Ref:	NR/L2/ELP/27009/MOD C63
Issue:	1
Date:	03/12/2011
Compliance date:	03/03/2012
Page	1 of 2

OVERHEAD LINE CAMPAIGN CHANGES – DATA SHEET

63

RENEW HIGH RISK PORCELAIN INSULATORS (SPANWIRE, TENSILE AND A682) PRONE TO FAILURE DUE TO DISCING.

Illustration of bending forces generated in a weakened insulator in tension (from Delta Rail)

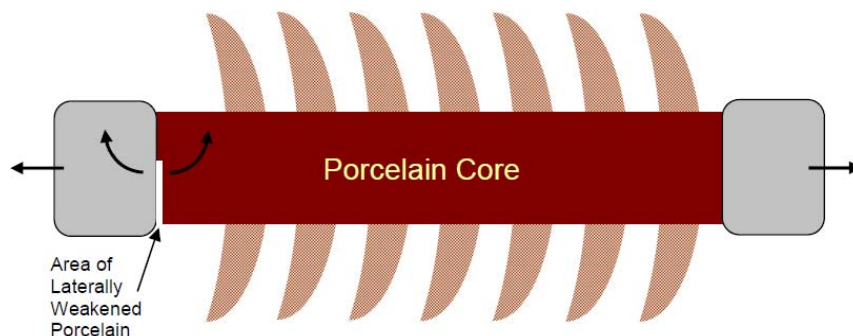
PROBLEM Water penetration at the end cap over time (at least 40 years) leads to an increased risk of insulator failure at the end cap and catastrophic failure.

OVERHEAD LINE CAMPAIGN CHANGES – DATA SHEET	
63	RENEW HIGH RISK PORCELAIN INSULATORS (SPANWIRE, TENSILE AND A682) PRONE TO FAILURE DUE TO DISCING.
ACTION REQUIRED	<p>Replace affected insulators with the polymeric equivalent insulator.</p> <p>Note that high impact porcelain types were sometimes used previously to replace normal porcelain types.</p>
